DATE MAILED: 04/29/2003

APPLICATION NO.	FILING DATE	FIRST NAMED INVENTOR	ATTORNEY DOCKET NO.	CONFIRMATION NO.
09/681,674	05/18/2001	Yoshifumi Natsuyama	JP92000096US1	3666
877 7	7590 04/29/2003			,
IBM CORPORATION, T.J. WATSON RESEARCH CENTER			EXAMINER	
P.O. BOX 218 YORKTOWN	HEIGHTS, NY 10598		RUDE, TIMOTHY L	
			ART UNIT	PAPER NUMBER
			2871

### **DETAILED ACTION**

Figure 11

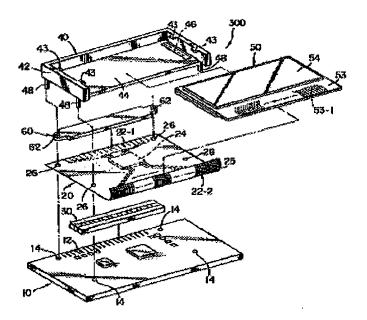
As to claim 4, Muramatsu discloses in his third embodiment, Figures 11 and 12, (col. 10 line 66 through col. 13, line 6) a liquid crystal display device, 50, comprising: a pair of glass substrates facing each other, each having electrodes for applying voltage to a liquid crystal material on a facing surface (typical); a circuit board, 10, for supplying said voltage; and a liquid crystal driver tape carrier package, 20, (col. 11, lines 7-9 and col. 7, lines 1-3) for connecting said electrodes of said glass substrates to said circuit board and mounting a liquid crystal driver chip (col. 11, lines 7-9 and col. 7, lines 4-13), wherein said liquid crystal driver tape carrier package and said circuit board anchor holes, 26 and 14, and anchor pins, 48, are inserted into said anchor holes, whereby said liquid crystal tape carrier package is fixed to said circuit board (col. 11, lines 45-48).

Muramatsu does not explicitly disclose a display wherein said liquid crystal driver tape carrier package is soldered to said circuit board via said pins.

As to claim 6, Muramatsu discloses the liquid crystal display device wherein a pair of said anchor holes, 26, is located with said liquid crystal driver chip, 24, between (diagonally per Figure 11).
